Office Action Summary		Applica	tion No.	Applicant(s)					
		09/895,	198	MULLER ET AL.					
		Examine	ər	Art Unit					
		НОА В.	TRINH	2893					
	The MAILING DATE of this communication appears on the cover sheet with the correspondence address Period for Reply								
A SHORTENED STATUTORY PERIOD FOR REPLY IS SET TO EXPIRE 3 MONTH(S) OR THIRTY (30) DAYS, WHICHEVER IS LONGER, FROM THE MAILING DATE OF THIS COMMUNICATION.  - Extensions of time may be available under the provisions of 37 CFR 1.136(a). In no event, however, may a reply be timely filed after SIX (6) MONTHS from the mailing date of this communication.  - If NO period for reply is specified above, the maximum statutory period will apply and will expire SIX (6) MONTHS from the mailing date of this communication.  - Failure to reply within the set or extended period for reply will, by statute, cause the application to become ABANDONED (35 U.S.C. § 133). Any reply received by the Office later than three months after the mailing date of this communication, even if timely filed, may reduce any earned patent term adjustment. See 37 CFR 1.704(b).

5. Claim 30-44 are rejected under 35 U.S.C. 103(a) as being unpatentable over Rostoke

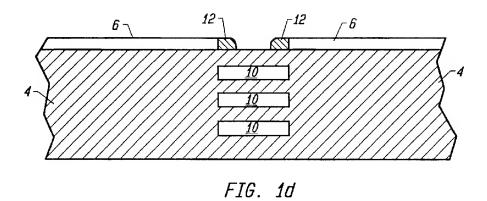
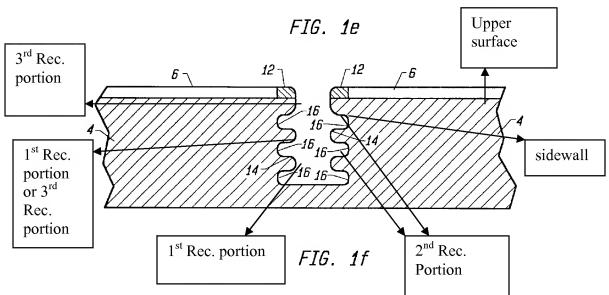
**As to claim 30**, Rostoker discloses an IC structure comprising a substrate 4 (fig. 1f) having an upper surface, wherein said substrate 4 comprises a substrate material 4; an opening (trench, fig. 1f) in the substrate 4 defined by said substrate material 4, wherein borders of the substrate material form a first rectangular portion originating with an intersection of said upper surface and said opening and a second rectangular portion, wherein the first rectangular portion has a larger dimensions in a horizontal direction than the second and third rectangular portions, wherein said horizontal direction is between sidewalls of said first rectangular portion and said second rectangular portion, and wherein said sidewalls are perpendicular to said upper surface; and a conductor 32 (figs. 1f, 3) filling the opening (trench, figs. 1f, 3). See marked-up figure 1f below.

As to claims 31, 41, the second rectangular is deeper in the opening (trench; fig. 1f) than the first rectangular portion (fig. 1f). See marked-up figure 1f below.

**As to claims 32, 42,** the first rectangular portion is deeper than the second rectangular portion. See marked-up figure 1f below.

**As to claims 33, 43,** the second rectangular portion increases a surface area of said opening (trench). See marked-up figure 1f below.

**As to claims 34, 44**, the second rectangular portion inherently increases a capacitance of the structure. See marked-up figure 1f below.

As to claim 35, Rostoker discloses an IC structure comprising a substrate 4 (fig. 1f) having an upper surface, wherein said substrate 4 comprises a substrate material 4; an opening (trench, fig. 1f) in the substrate 4 defined by said substrate material 4, wherein borders of the substrate material form a first rectangular portion originating with an intersection of said upper surface and said opening, a second rectangular portion and a third rectangular portion, wherein the first rectangular portion has a larger dimensions in a horizontal direction than the second and third rectangular portions, wherein said horizontal direction is between sidewalls of said first rectangular portion, second and said third rectangular portion, and wherein said sidewalls are perpendicular to said upper surface; and a conductor 32 (figs. 1f, 3) filling the opening (trench, figs. 1f, 3). See marked-up figure 1f below.

**As to claim 36**, said second rectangular portion is between said first rectangular portion and said third rectangular portion. See marked-up figure 1f below.

**As to claim 37**, said first rectangular portion and said third rectangular portion have substantially similar dimensions. See marked-up figure 1f below.

**As to claim 38**, said second rectangular portion increases increase a surface area of said structure. See marked-up figure 1f below.

As to claim 39, the first rectangular portion and the third rectangular portion have different dimensions (fig. 1f) in said horizontal direction. See marked-up figure 1f below.

As to claim 40, Rostoker discloses an IC structure comprising a substrate 4 (fig. 1f) having an upper surface, wherein said substrate 4 comprises a substrate material 4; a bottled shaped opening (trench, fig. 1f) in the substrate 4 defined by said substrate

material 4, wherein borders of the substrate material form a first rectangular portion located completely below and having no portion thereof coincident with said upper surface, and a second rectangular portion located below said first rectangular portion and bounded on two sides by a mask material deposited on said substrate material, wherein the first rectangular portion has a larger dimensions in a horizontal direction than the second and third rectangular portions, wherein said horizontal direction is between sidewalls of said first rectangular portion and said second rectangular portion, and wherein said sidewalls are perpendicular to said upper surface; and a conductor 32 (figs. 1f, 3) filling the opening (trench, figs. 1f, 3). See marked-up figure 1f below.
